**Title: Combined Stage 1&2 Road Safety Audit**

**Proposed Residential Development at Ardclough Road,  
Celbridge Co. Kildare.**

**Client: Kildare County Council**

**Report reference: 1394R01**

Drawing 11162-2030 P02, Sightlines at proposed junction.

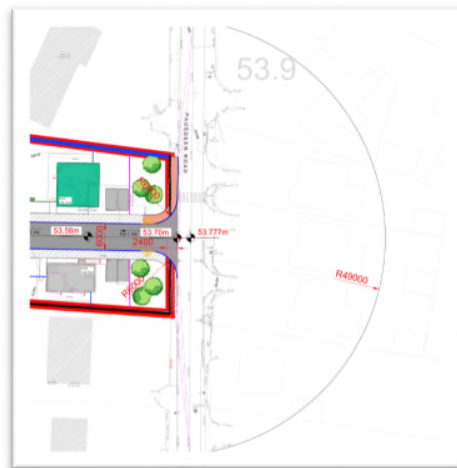
The sightlines are shown to the centre of the carriageway. This is a section of carriageway with a broken line. Drivers may overtake slow moving vehicles and not be seen by drivers exiting the development leading to side-impact collisions.

It is recommended that the appropriate sightlines should be provide to the nearside edge of the carriageway.

3.1	yes	yes	Please see Drawing attached with sightlines revised, 11162-2030.	
3.2	no	no	6m radius is necessary for large vehicles, Please see attached drawing showing road markings and signage, 11162-2031.	Yes

Drawing 11162-2030 P02, Corner radii.

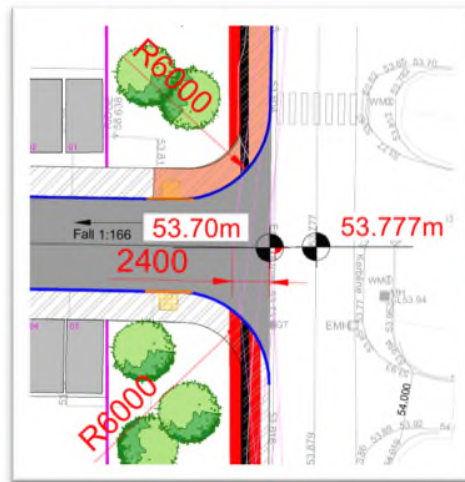
It is proposed to provide corner radii of 6m at the priority junction with Ardclough Road. This could lead to high turning speeds resulting in high severity injuries if a crossing pedestrian is struck. It may also lead to drivers not seeing cyclists in their 'blind spots' as they turn left into the development.

It is recommended that the corner radii be reduced.

Drawing 11162-2030 P02, Pedestrian crossing of Ardclough Road.

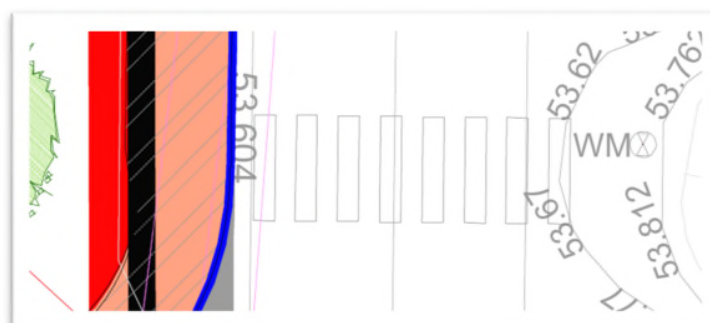
It is unclear what type of pedestrian crossing is proposed across Ardclough Road. The proposed marking suggest a zebra type crossing however there is no proposal for beacons. The use of striped marking could lead to confusion over priority between pedestrians and drivers leading to collisions.

It is recommended that either a controlled pedestrian crossing or uncontrolled crossing be provided with dropped kerb and suitable tactile paving.

3.3	yes	yes	Please see updated drawing showing an uncontrolled crossing with drop kerbs each side, and appropriate buff tactile paving, 11162-2030.	
3.4	yes	yes	Drop kerbs have been added to back of all the perpendicular car parking spaces, please see updated drawing 11162-2030.

Drawing 11162-2101 P02, Refuse Truck Swept Path.

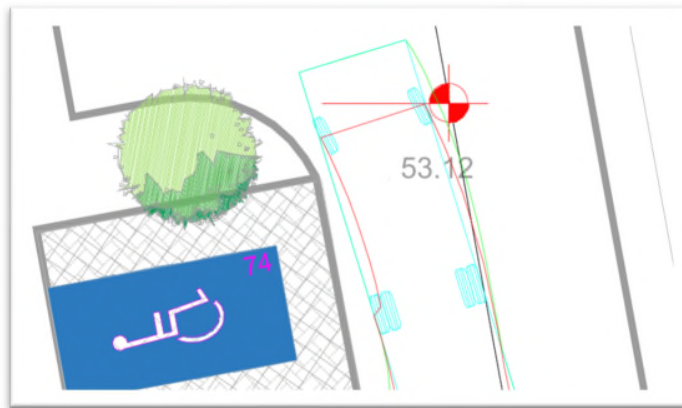
The swept path analysis for the refuse truck uses a two axel vehicle and does not show the turning manoeuvre at the turning heads. There is a risk that the commonly use three axel vehicles may not be able to turn in the space provided especially with the turning heads being partially occupied by car parking spaces.

It is recommended that the full manoeuvres be carried out for the three axle vehicles.

3.5	yes	yes	West turning bay has been updated so 3 Axle bin lorries can maneuver. See updated drawing 11162-2101	
3.6	yes	yes	Lights to be located in green areas, Not in footpaths, please see updated lighting drawing.

Drawing 210303-2-007 Rev – VHA, Pedestrian Bridge.

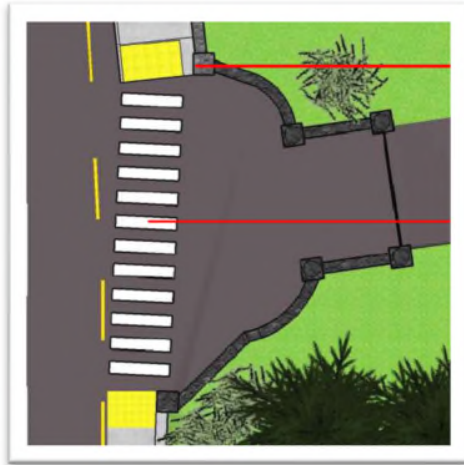
It is proposed to have a pedestrian crossing across the Bruach an Pháistín entrance. The zebra crossing type marking may lead to confusion over priority resulting in collisions.

It is recommended that an uncontrolled crossing be provided. As it is a very lightly used entrance the footpath could be made continuous to give better priority to pedestrians.

3.7	yes	yes	The junction and crossing will be lit.	
3.8	Yes	yes	Crossing shall be marked as an uncontrolled crossing not as zebra crossing markings.	
3.9	yes	yes	the crossing will not be a zebra crossing and will be an uncontrolled crossing.
